| Project                      | <b>IEEE 802.16 Broadband Wireless Access Working Group</b> < <a href="http://ieee802.org/16">http://ieee802.org/16</a> >  |  |
| Title                        | <b>Radio Resources Sharing Opportunities Advertisement Discovery</b>  |  |
| Re:                          | IEEE 802.16h-06/011 – Working Group Review  |  |
| Abstract                     | This contribution proposes fast, reliable and secure over the air advertisement discovery mechanisms in support of the credit tokens based BS-BS rental protocol. Advertisement discovery information between master and slave BSs (and conversely) is conveyed by SSs acting as RF bridges. New text is proposed to be included in the IEEE 802.16h working document.  |  |

Figure 1: MAC frame structure for radio resources sharing opportunities advertisement discovery

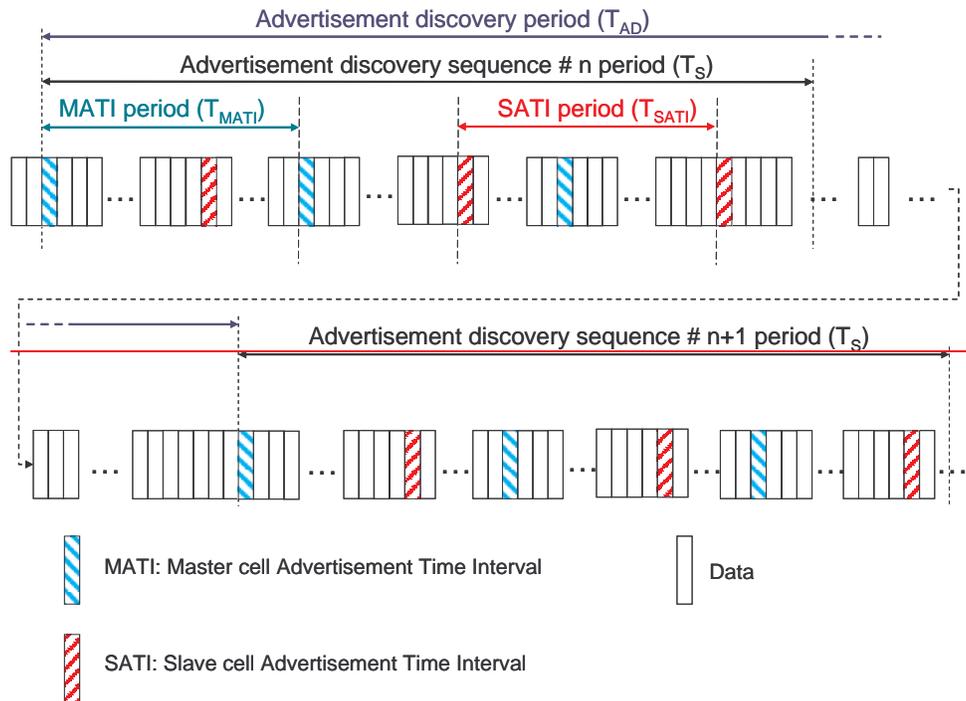
~~On a given channel (frequency domain), Figure 1 describes the MAC frame structure enabling the support of the discovery of the temporarily radio resource sharing opportunities between the master and slave BSs. This MAC frame is structured as follows:~~

- ~~• An Advertisement discovery sequence is periodically ( $T_s$  *TDB*) inserted in the data frame to support the discovery for two cases:~~

- Discovery of the master BS' offers by the slave BSs,
- Discovery of the slave BS' requests by the master BSs.
- The Discovery of the master BSs' offers is enabled by the usage of the Master Advertisement Time Interval (MATI).

- The Discovery of the slave BSs' requests is enabled by the usage of the Slave Advertisement Time Interval (SATI).
- The number ( $N_{MATI}$  *TBD*) of MATI and the number ( $N_{SATI}$  *TBD*) of SATI within the Advertisement discovery sequence can be adjusted in response to the context (e.g. number of active master and slave cells) to avoid to waste capacity. For example (in Figure 1), the number of MATI and SATI is the same within the sequence #n, but different numbers of MATI and SATI in a sequence can be considered. Also, the MATI and SATI are not necessary alternately interleaved as depicted in Figure 1. The total number of MATI + SATI ( $N_{MATI} + N_{SATI}$ ) can be bounded by the average total number of possible neighbours in the co-existence neighbourhood.

- The Advertisement discovery sequence periodically occurs every Advertisement discovery period  $T_{AD}$ . This period  $T_{AD}$  (*TBD*) can also be adjusted in response to the context (e.g. number of master and slave cells).

- The positions of the MATI, SATI in the frame are synchronised and identified by UTC stamps.

Figure 12: Policy instructions to the slave SSs by the slave BSs

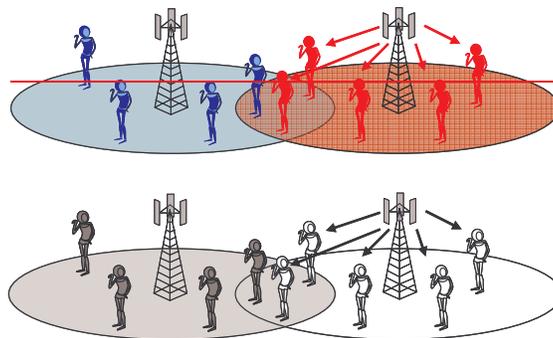
- During this step, the slave BS initially instructs (by broadcasting) its SSs (in red) about the behaviours they have to adopt when some of these SSs get the messages from the different MATIs.
- The behaviour is instructed by the ADPD (Advertisement Discovery Policy Descriptor) message (section 6.3.2.2.66) specifies when some SSs (located in the overlapped area between this slave cell and surrounding master cells and getting MADD message from master BS) associated to this slave BS have to report the MADD information conveyed in MATI towards this slave BS.
- ~~In particular, the slave BS could instruct about (Table h3):~~
  - ~~o(a) The starting ( $T_{start-S}$ ) and ending ( $T_{end-S}$ ) times (period [ $T_{start-S}$  ;  $T_{end-S}$ ]) this slave BS would be interested to rent in case some radio resources would be opened for renting by the master BSs.~~

~~o(b) The maximum admissible reserved price  $RPA_{max\_S}$  (expressed in term of number of credit tokens number per radio resources unit) until which the slave BS would be ready to spend when entering into any auctioning cycle of the rental protocol.~~

~~If (a) and (b) are checked,~~ The slave SSs that can hear the MATIs and meeting the requirements sent in ADPD are the only SSs that are allowed to make the RF bridge between the master and slave cells. This means, the policy rules the transmissions from any slave SS towards the slave BS when these SSs are mandated to get feedback about the MATIs proposals. This mechanism avoids having incessant transmissions from the slave SSs towards the slave BS when the MATIs are not aligned with the slave BSs strategy. This saves bandwidth. Any policy can be established. Moreover, the policy can be adapted dynamically in time by the slave BS.

Figure 23: Detection and identification of the MATIs content by the slave SSs

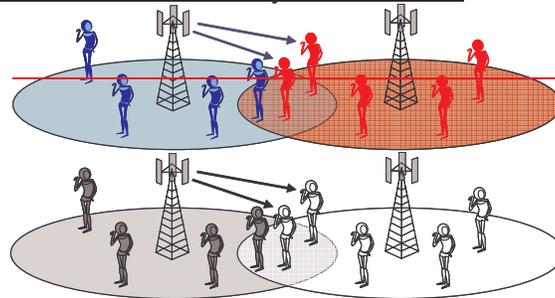
- During this step, the slave SSs in the overlapping area between the master cell and their slave cell listen to the different MATIs sequentially. For each master cell, these slave SSs can get the following information sent in the MADD message (Section 6.3.2.2.64):  ~~$IPid\_M$ ,  $BSid\_M$ ,  $T_{Start\_M}$ ,  $T_{End\_M}$ ,  $RPA\_M$  and  $LC$ .~~
- Provided the MADD message information ~~( $T_{Start\_M}$ ,  $T_{End\_M}$ ,  $RPA\_M$ )~~ received and the ADAP message received about the policy (section 6.3.2.2.66) ~~policy (about  $T_{Start\_S}$ ,  $T_{End\_S}$  and~~

$RPA_{max\_S}$ ) established by the slave BS, the slave SS is able to decide whether it has to transmit this information to the slave BS or not.

Figure 34: Relaying of the MATIs content to the slave cell by the slave SSs

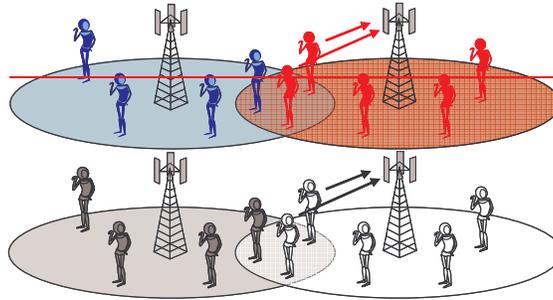
- In case the policy requirements are met, the information collected by the slave SS is conveyed to the slave BS. The information the slave SS sends to its BS is the content of the MADD message:  $IPid\_M, BSid\_M, T_{Start\_M}, T_{End\_M}, RPA\_M$  and  $LC$ .
- In order to ensure this information is appropriately received by the slave BS, the information is sent by several slave SSs (e.g. 2 slave SSs circulate this information to the slave BS in Figure 3Figure 4). This ensures both reliability and security check.

Note: In case the policies requirements sent in ADAP are not met, the slave SSs do not transmit the information. However, it would be possible for the slave SS to convey the information about the list LC (message included in MADD) to its slave BS since it will provide it some further information about other radio resources renting opportunities on other channel (frequency domain). This decision to send the LC information ~~can~~ could be ruled by the policy.

Figure 45: Master-Slave BS communication through the backhaul

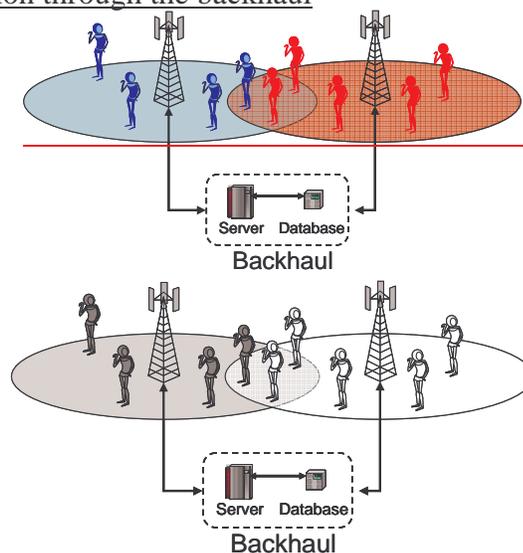
After step 3, the slave BS knows the IP\_Proxy\_address\_M (Section 6.3.2.2.64) ~~IPid\_M and BSid\_M~~ associated to ~~of~~ the master cell. Accordingly, the communications between master and slave cells (BSs) is performed through the backhaul to make the negotiation (Figure 4~~Figure 5~~) with the co-existence protocol (CP). The remaining phases of the credit tokens based ~~auctioning/bidding cycle~~ negotiation cycle is performed via this backhaul with IP based communications using server(s) and database(s).

Figure 56: Detection and identification of the SATIs content by the master SSs

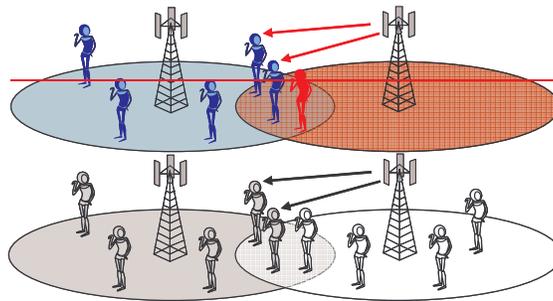
⊞ During this step (Figure 5), the master SSs in the overlapping area between the master cell and their slave cell listen to the different SATIs sequentially. For each slave cell, these master SSs can get the ~~following~~ information contained in the SADD message. ~~: IPid\_S, BSid\_S, T\_Start\_S, T\_End\_S.~~

- ~~• This information is reported by the master SS to its master cell.~~
- ~~• In order to ensure this information is appropriately received by the master BS, the information is sent by several master (e.g. 2 master SSs convey this information to the master BS in Figure 6). This ensures both reliability and security check.~~

Figure 7: Master BS – Slave BS communication through the backhaul

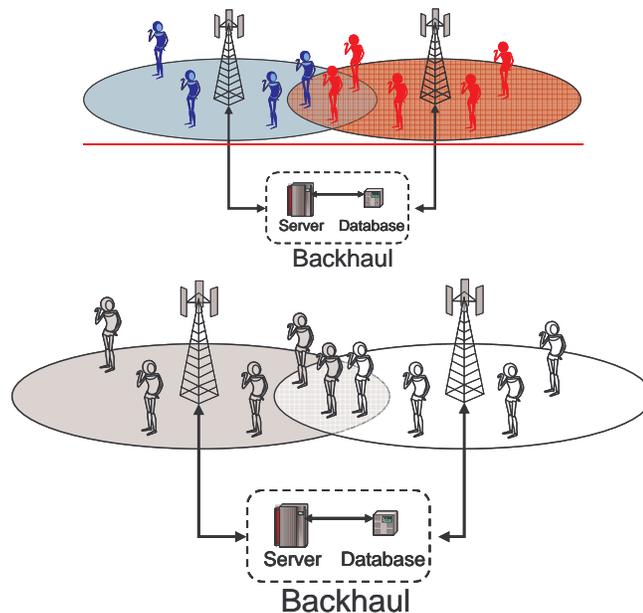
After step 23, the master BS knows the  $IP\_Proxy\_address\_S$  (Section 6.3.2.2.65)  $IPid\_S$  and  $BSid\_S$  of the slave cell. Accordingly, the communications between master and slave cells (BSs) is performed through the backhaul to make the negotiation (Figure 7) with the co-existence protocol (CP). The remaining phases of the credit tokens based auctioning/bidding negotiation cycle is performed via this backhaul with IP based communications using a server and database.
